Proposal Request

PROJECT: *(name and address)*
AWSOM
Bentonville, Arkansas

PROPOSAL REQUEST 084

TBLH AV Revisions

1 2410 TEAM BASED LEARNING HALL - SOUTH
1/4" = 1'-0"

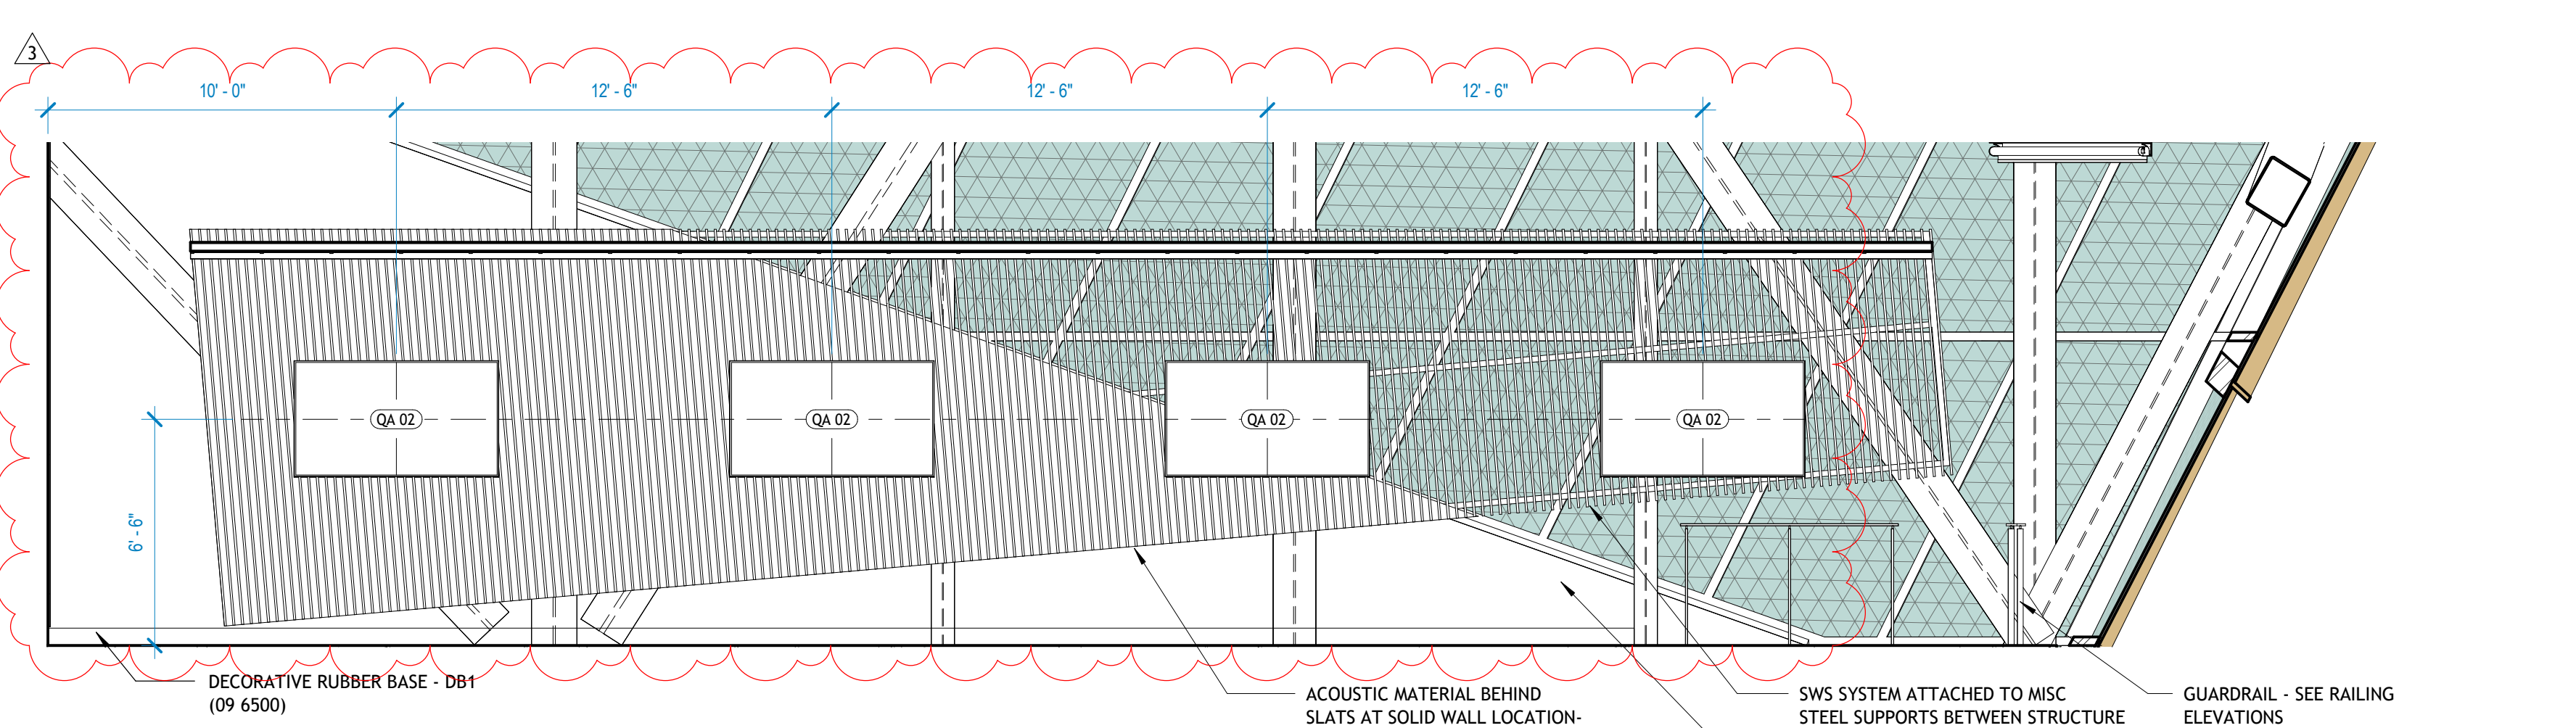
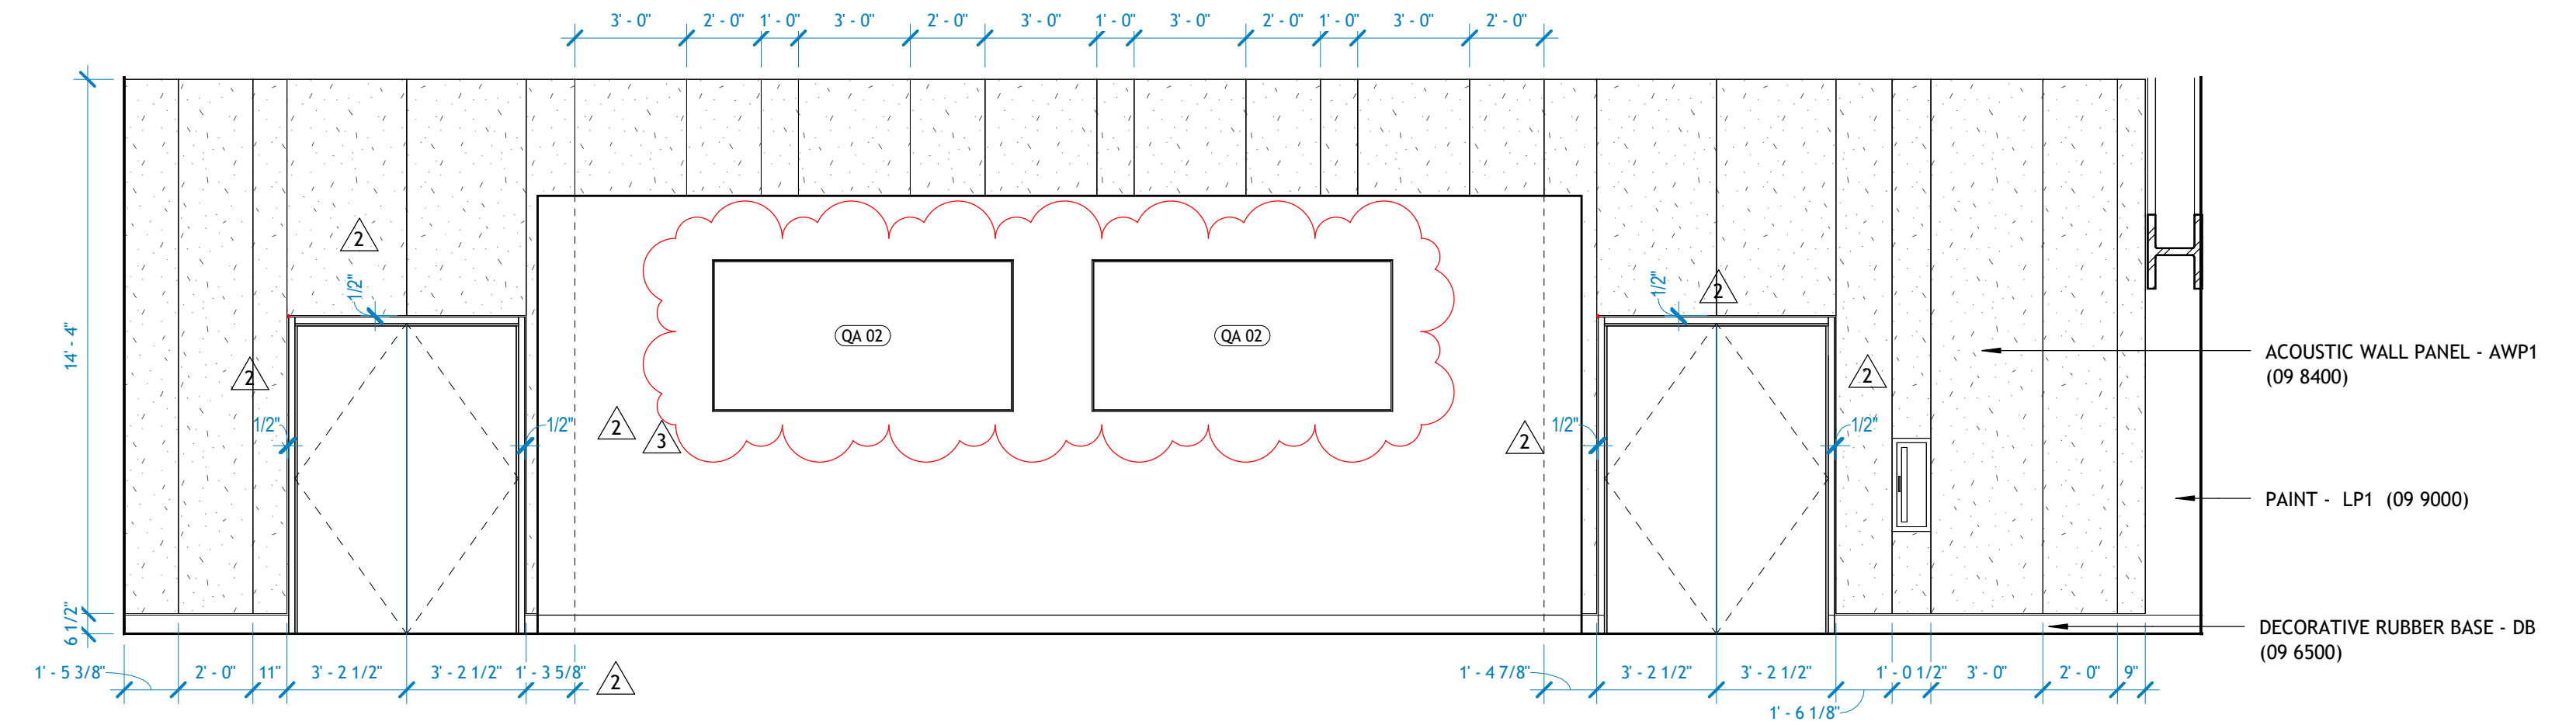
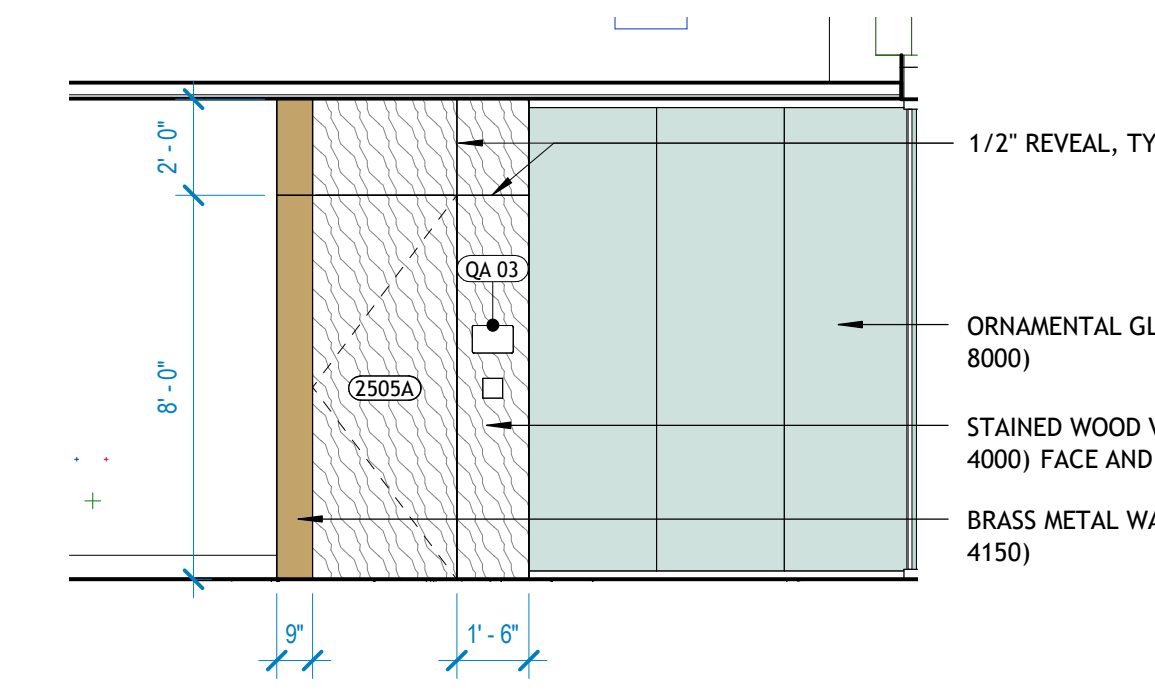
- a) Refer to Revised Sheet **A622**, with original issue date 02.24.2023 and revised date 09.25.2024.
 - Details 1, 1B, and 1E revised to show updated layout and amounts of TVs.
- b) Refer to Revised Sheet **A623**, with original issue date 02.24.2023 and revised date 09.25.2024.
 - Details 1, 2, and 3 revised to show updated layout and amounts of TVs.
- c) Refer to Revised Sheet **A912A**, with original issue date 02.24.2023 and revised date 09.25.2024.
 - Details 1, revised to show updated layout and amounts of TVs.

1 AUDIO-VIDEO - LEVEL 2 PLAN - AREA A
1/8" = 1'-0"

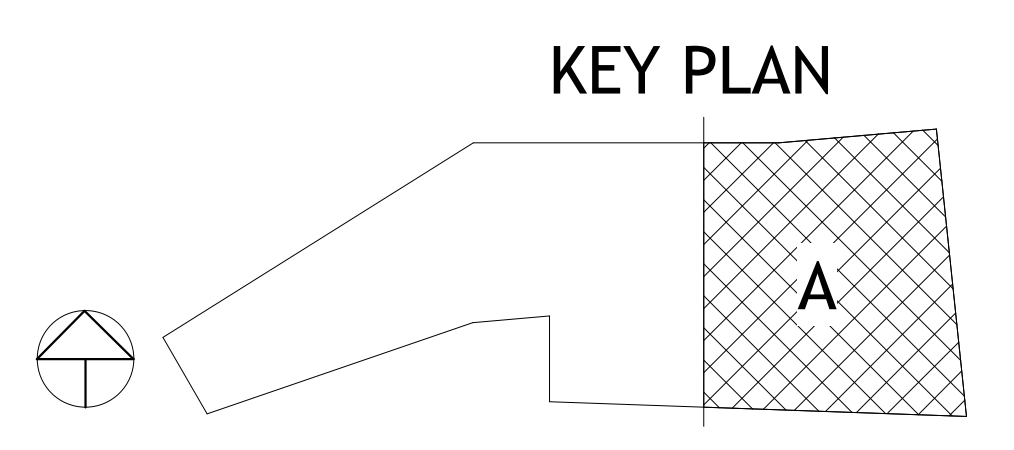
- a) Refer to Revised Sheet **TA102A**, with original issue date 02.24.2023 and revised date 09.25.2024.
 - Added sheet note.
 - Added flat panel displays and associated wall boxes to north wall of Team Based Learning Hall 2410.

- Renumbered devices in Team Based Learning Hall 2410.
 - Added wall boxes for future flat panel displays to south wall of Team Based Learning Hall 2400.

- Renumbered devices in Team Based Learning Hall 2400.
- b) Refer to Revised Sheet **TA402**, with original issue date 03.09.2023 and revised date 09.25.2024.

Contents:
AUDIO-VIDEO SIGNAL FLOWS

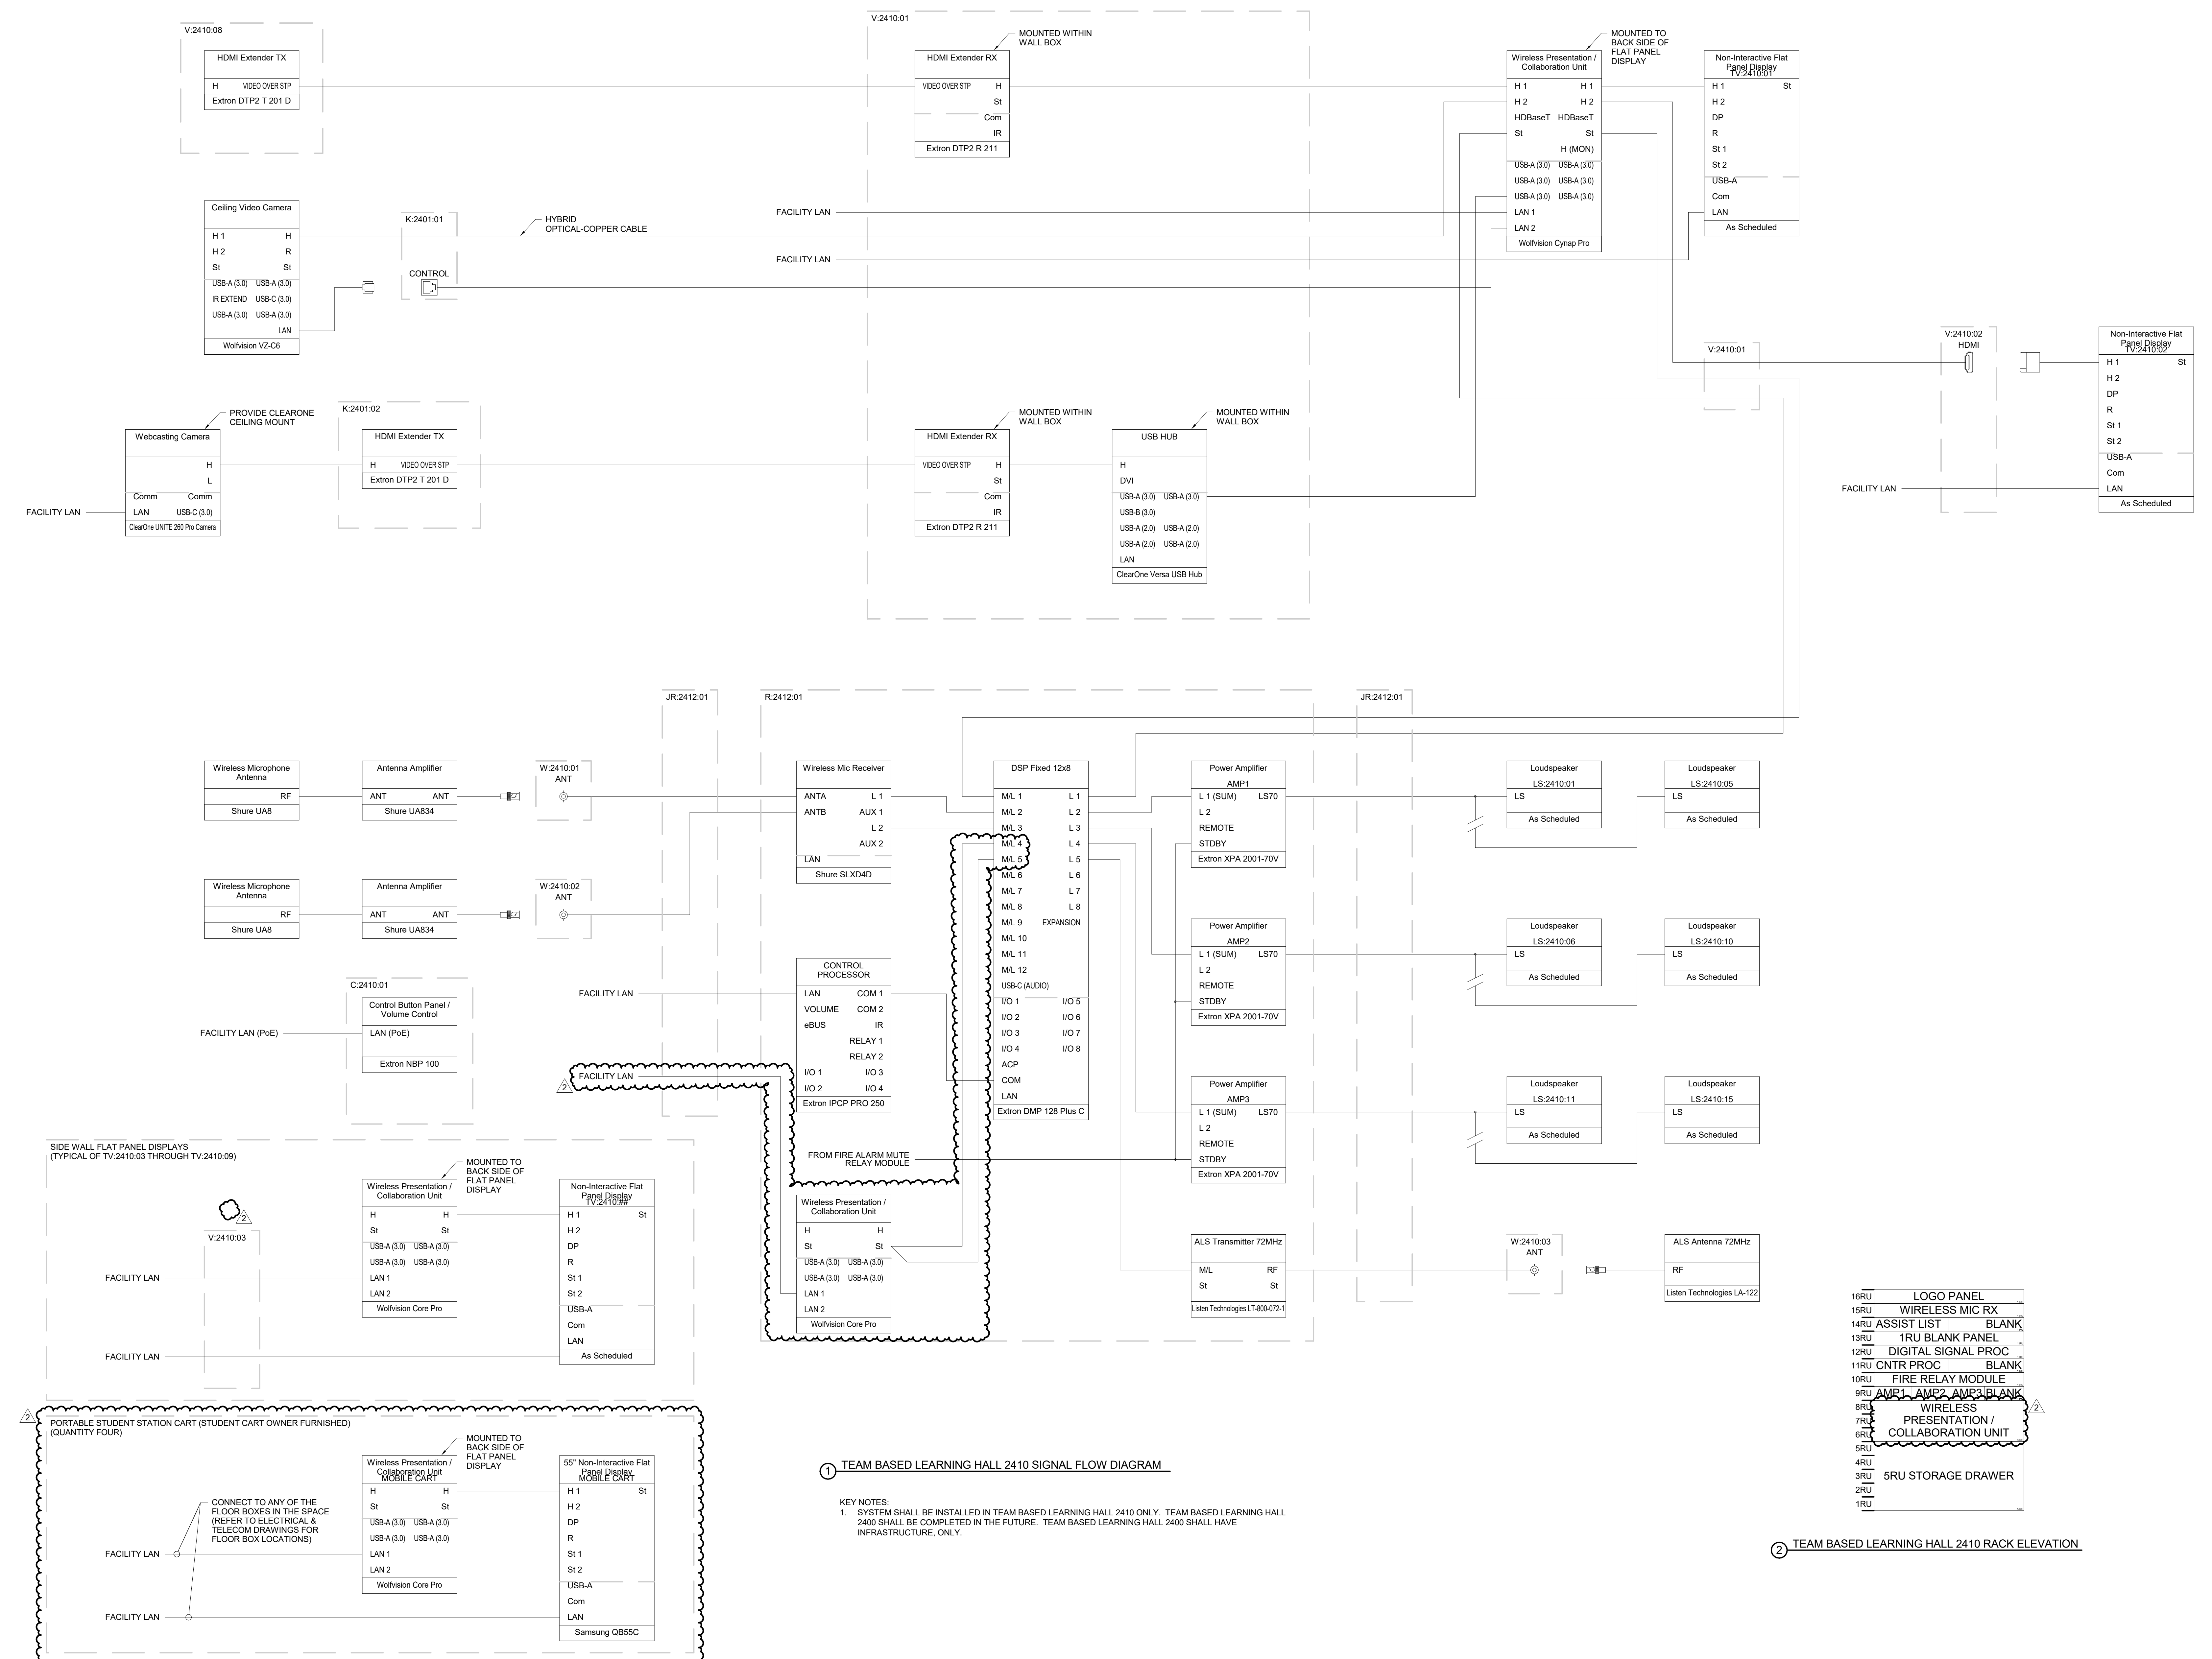
- Revised schedule to reflect changes on sheet TA102A.
- d) Refer to Revised Sheet **TA704**, with original issue date 02.24.2023 and revised date 09.25.2024.

- Revised device numbering to reflect changes on sheet TA102A.
 - Added devices to accommodate needs of portable student station carts.
 - Revised equipment rack layout.

TECHNOLOGY - LEVEL 2 PLAN - AREA A
 1/8" = 1'-0"

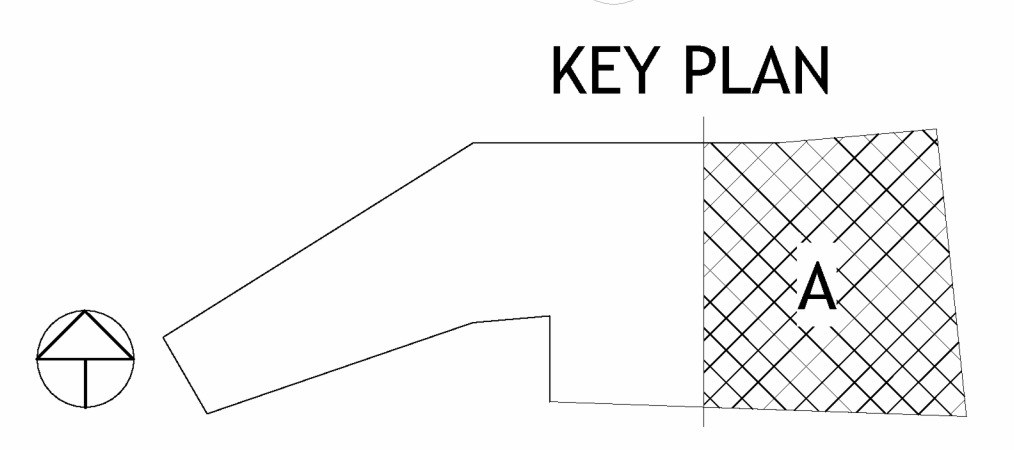
- a) Refer to Revised Sheet **TN102A**, Detail 1, with original issue date 02.24.2023 and revised date 09.25.2024.
- Revised quantity and locations of TV data outlets in Team Based Learning Hall #2400 and Team Based Learning Hall #2410.
